Darling Square NE Plot

Design Report for Section 96 Application to Modify SSDA7

Prepared for
Lendlease
December 2016

2.3 External Amendments - Podium Plan

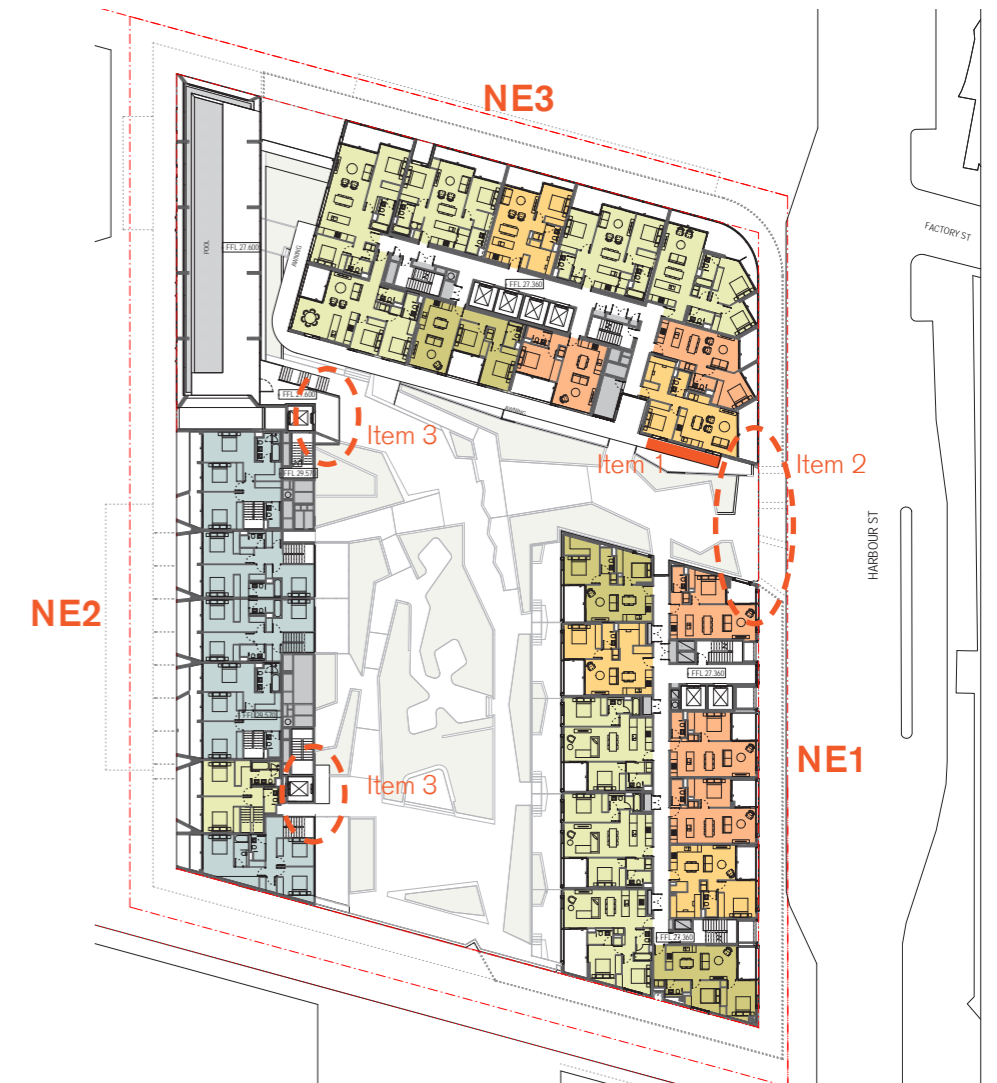
Minor modifications are proposed to the podium to improve the amenity for the occupants. These include:

1. An extension of the podium awning at the base of the NE3 tower. This will mitigate the wind effects to the podium apartment located to the South East of the tower.
2. The planted edges between NE1 and NE3 have been setback 1-1.5m from the balustrade. This removes any climbing ledges and eliminates the need to increase the balustrade beyond 1100mm high.
3. A framed masonry portal has been added to the lifts of NE2 to provide weather protection as further detailed on page 15.

2.3 External Amendments - NE2 East Facade

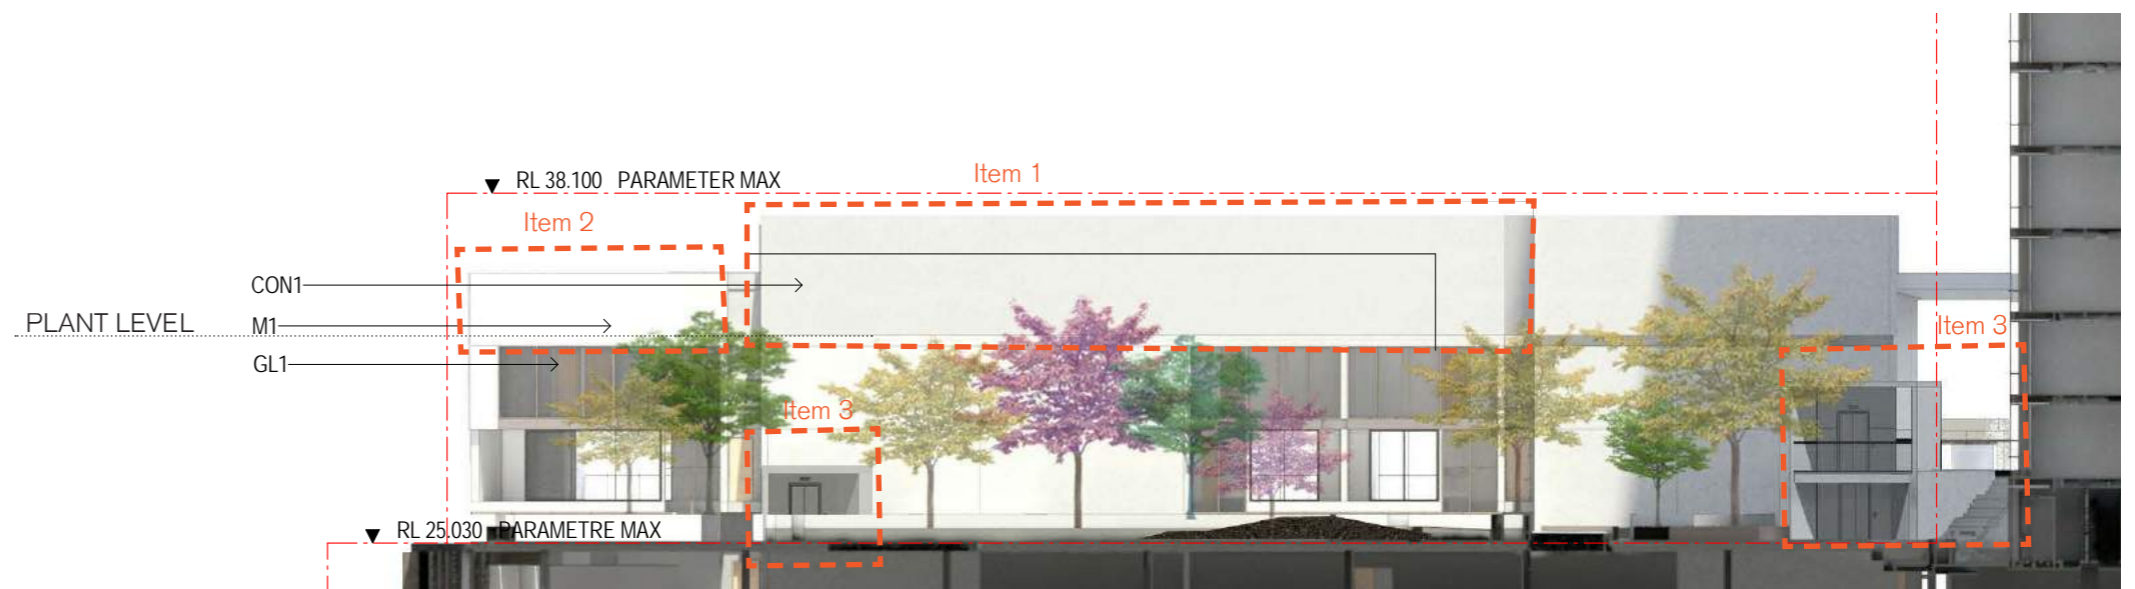
The Eastern facade of the NE2 building has been amended to address the following:

1. Redundant plant louvres have been replaced with a class 2 concrete finish, consistent with the remaining facade.
2. Due to the plant floor levels, the glass has been lowered to match the apartment ceiling height.
3. A framed masonry portal has been added to the lifts of NE2 to provide weather protection.

2.3 External Amendments - NE3 Tower West Facade Glazing

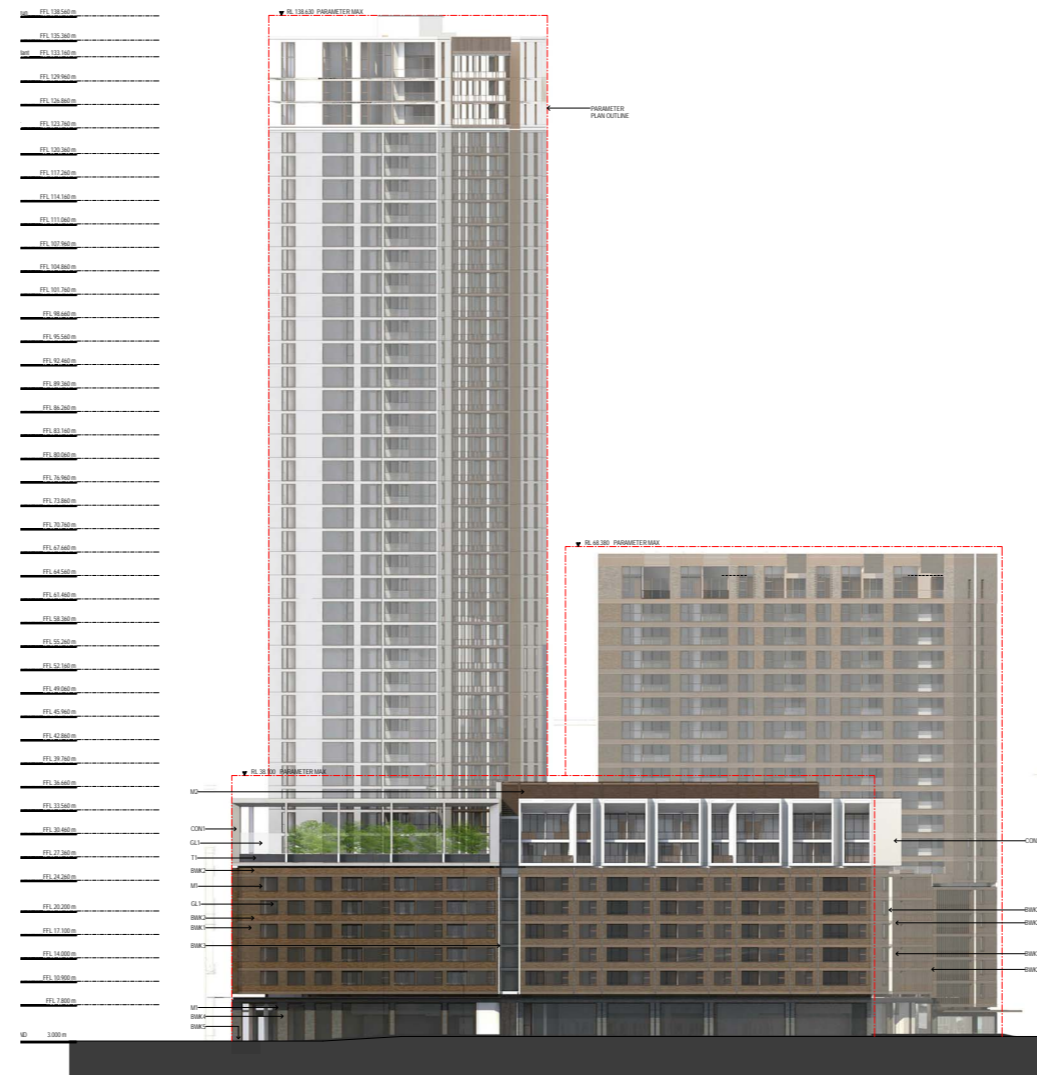
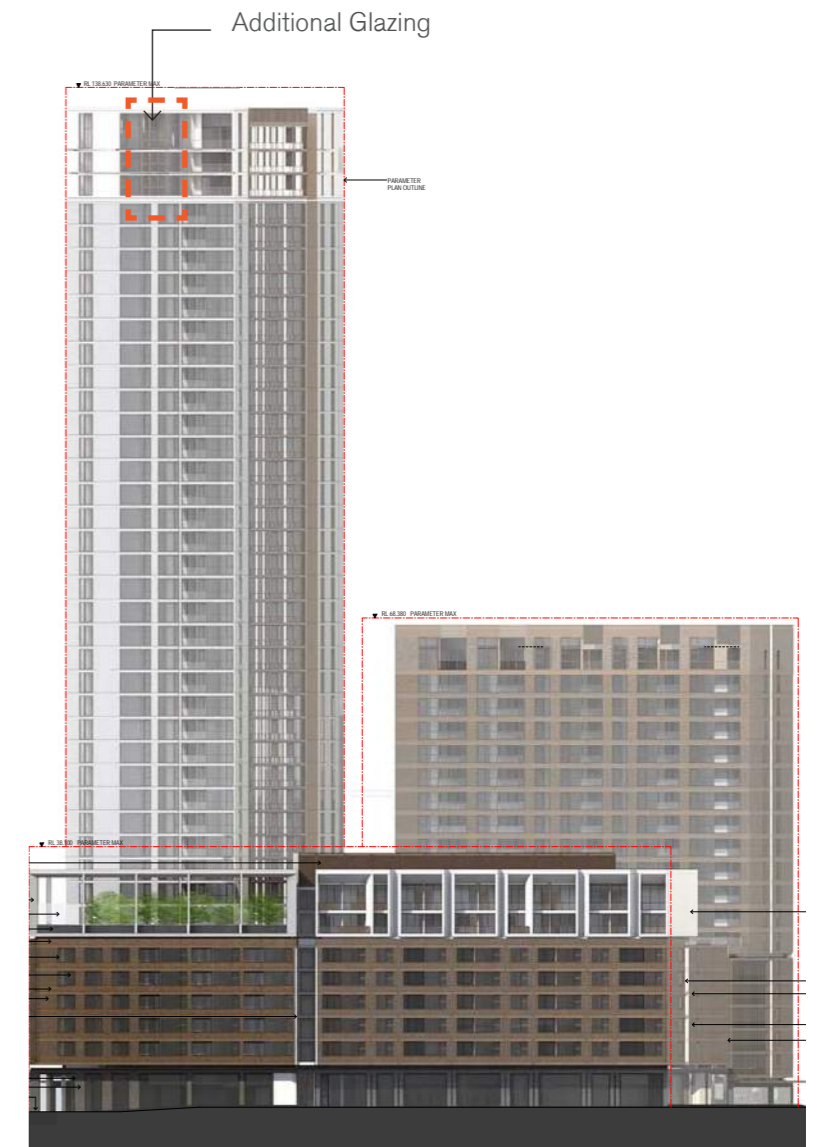
The extent of glazing to Level 38-40 has been slightly increased to better address the internal planning of the L38 to L40 apartments and improve their amenity.

2.2 External Amendments - Foyer Parapet

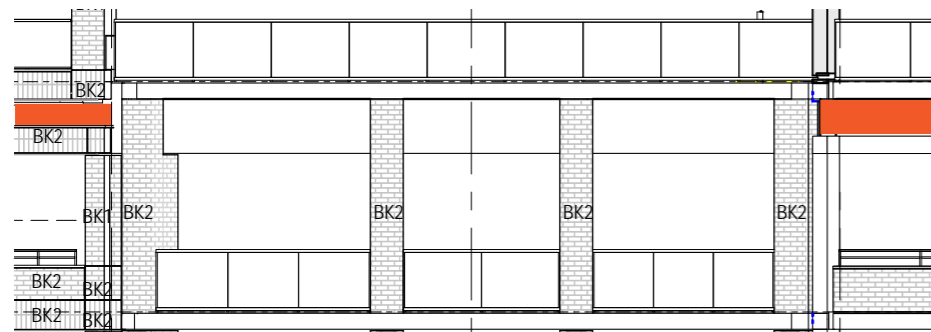
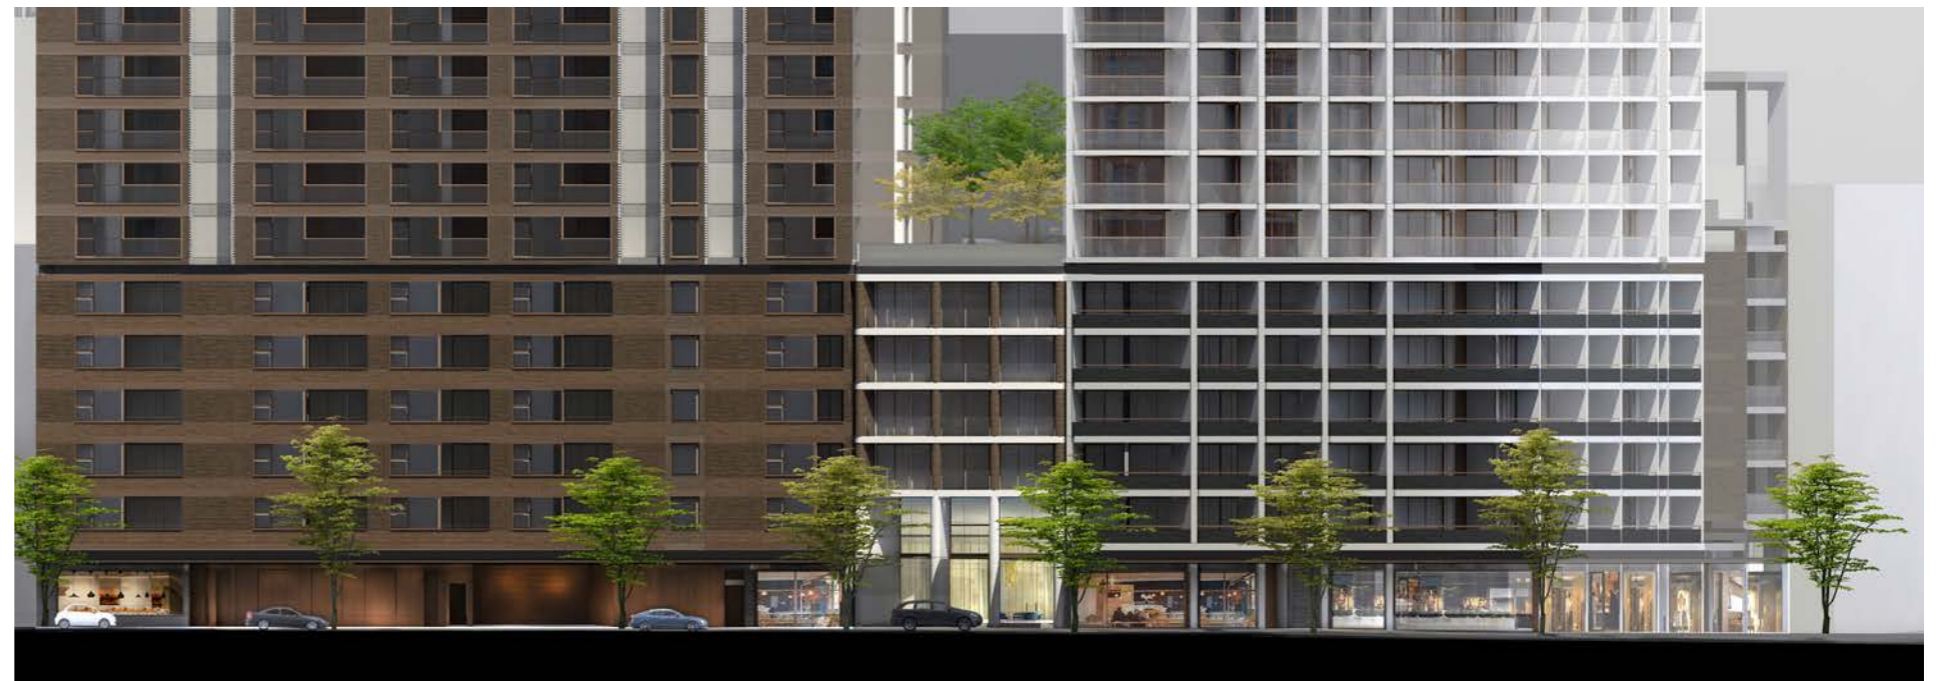
The alignment between NE1 and NE3 re-entrant could not be achieved due to the following reasons:

- Brick dimensions and setout of the soldier course
- Concrete thickness of the re-entrant to NE3
- Services reticulation for the overland flow and hydraulic pipes of the podium transferring down to ground causing a misalignment in the vertical face of the foyer re-entrant and NE3 re-entrant

To preserve the design integrity and intent of the re-entrant, the foyer detailing has been amended. The columns over the foyer have been extended to re-inforce the vertical fenestration of the entry. The amendments retain the following key principles:

- Preserves the alignment of the parapet folds and key datums which articulate the podium re-entrant
- Provides a transition between NE1 brick building and NE3 tower
- The character of the built form is retained.

Brick columns extended and soffit modified

2.3 External Amendments - Retail Portals West Facade

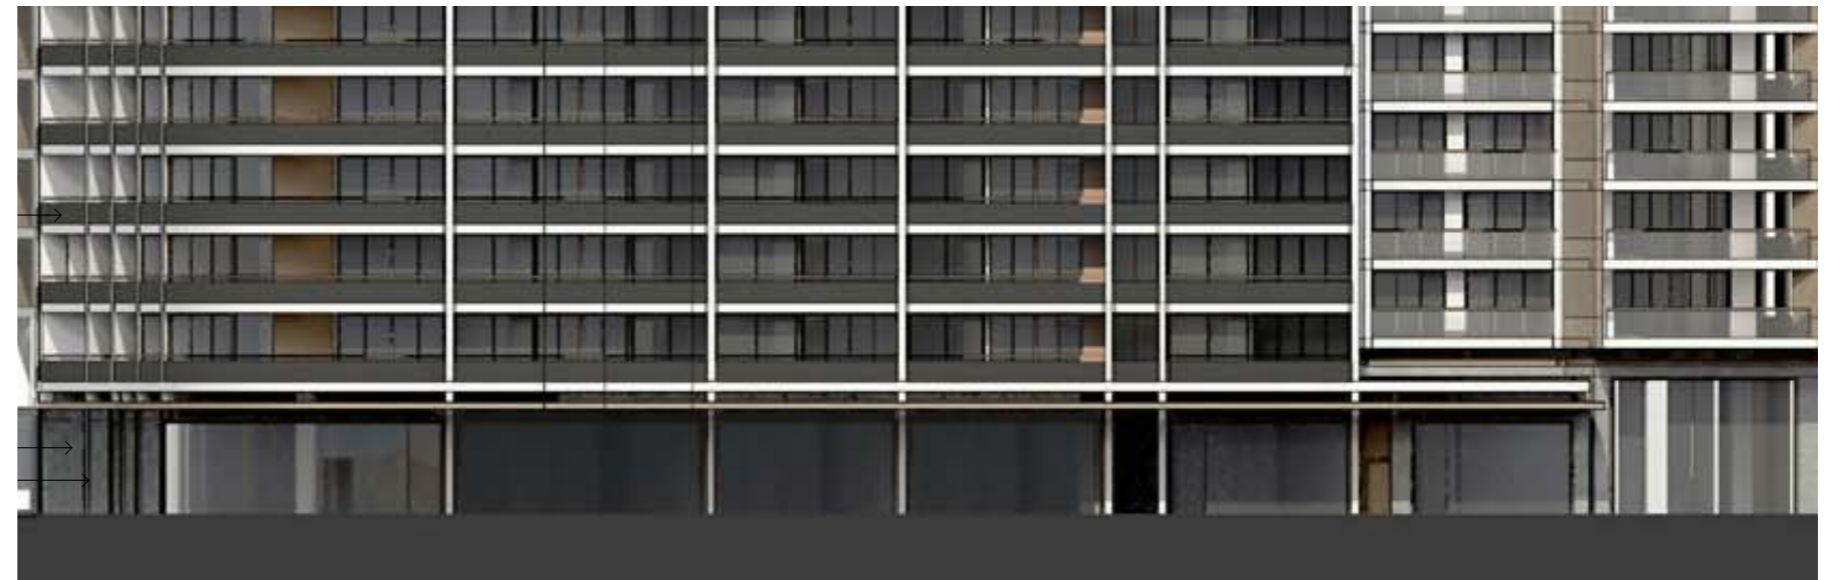
Additional brick columns have been added to the NE2 ground floor elevation. The detailing of the columns is consistent with the current piers and align with the fenestration to the building above.

The additional columns also reduce the spans of the openings and provide flexibility to the tenancy sizes.

2.3 External Amendments - Retail Base with flood freeboard

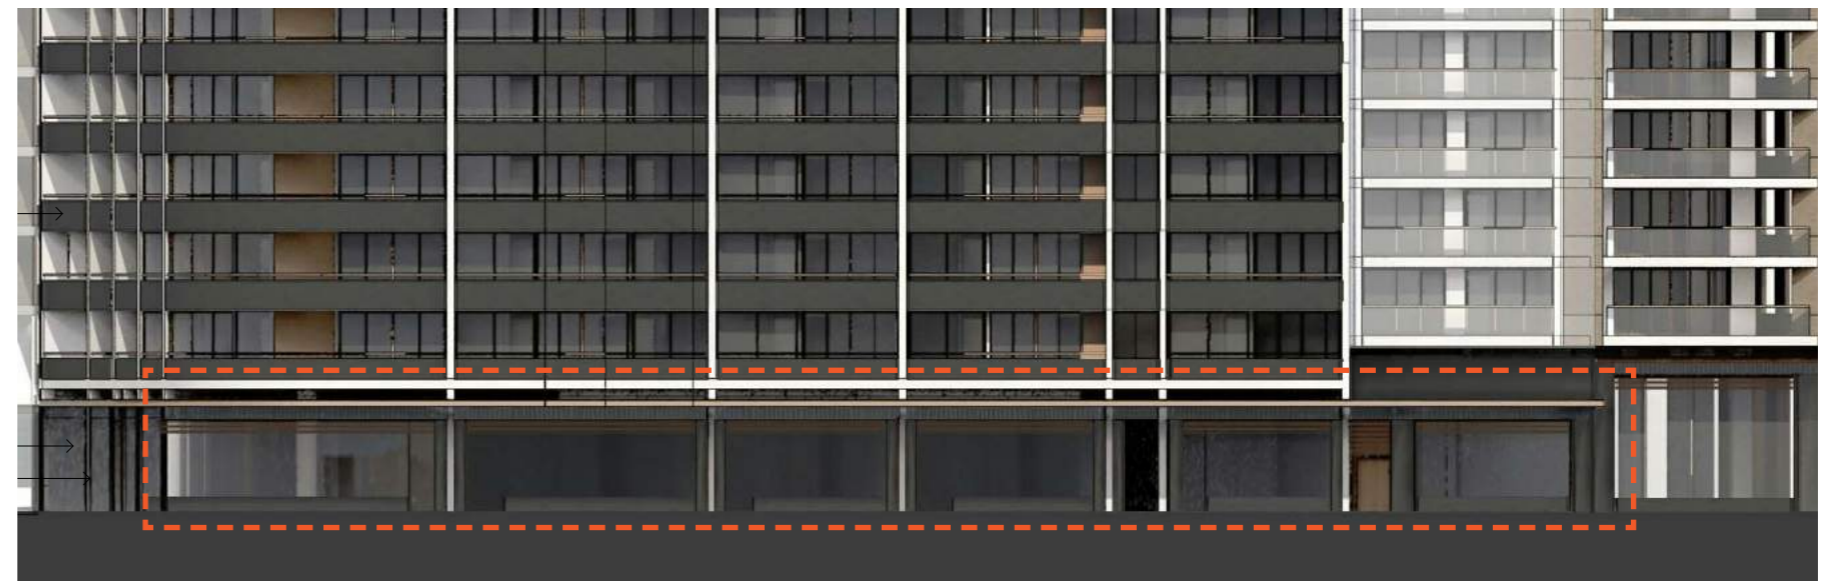
Additional brick piers and brick upstands have been added to the retail base along Factory Lane, Harbour Street and Little Hay.

The addition of the brick provides a consistent language to all the openings around the North East Plot, with slight variations where an upstand is required as a flood mitigation response.

Establishing a considered and consistent character for the retail base will provide a coherent identity to the retail tenancies of the North East Plot and further reinforce the building coming to ground.

This approach to the base building retail design will still allow for retail tenants to have the flexibility to infill the portals with a 'kit of parts' to suit each individual use.

2.3 External Amendments - Louvres on South Facade

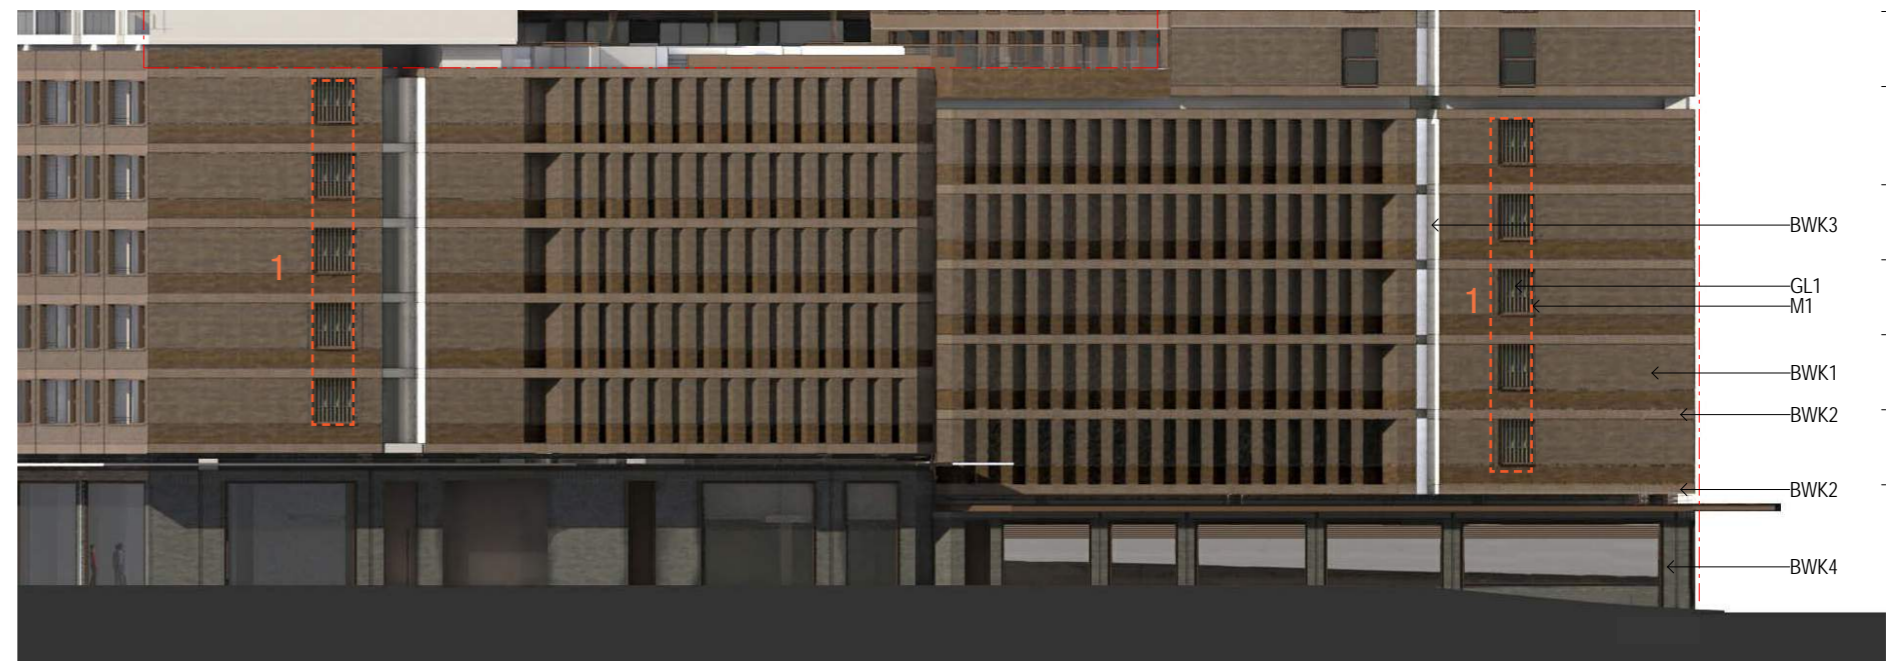
Vertical aluminium screens added to the southern windows of habitable rooms along the southern facade on levels 1 to 5 to address privacy and overlooking concerns triggered by the proximity and the design of SE Plot (SSDA6633).
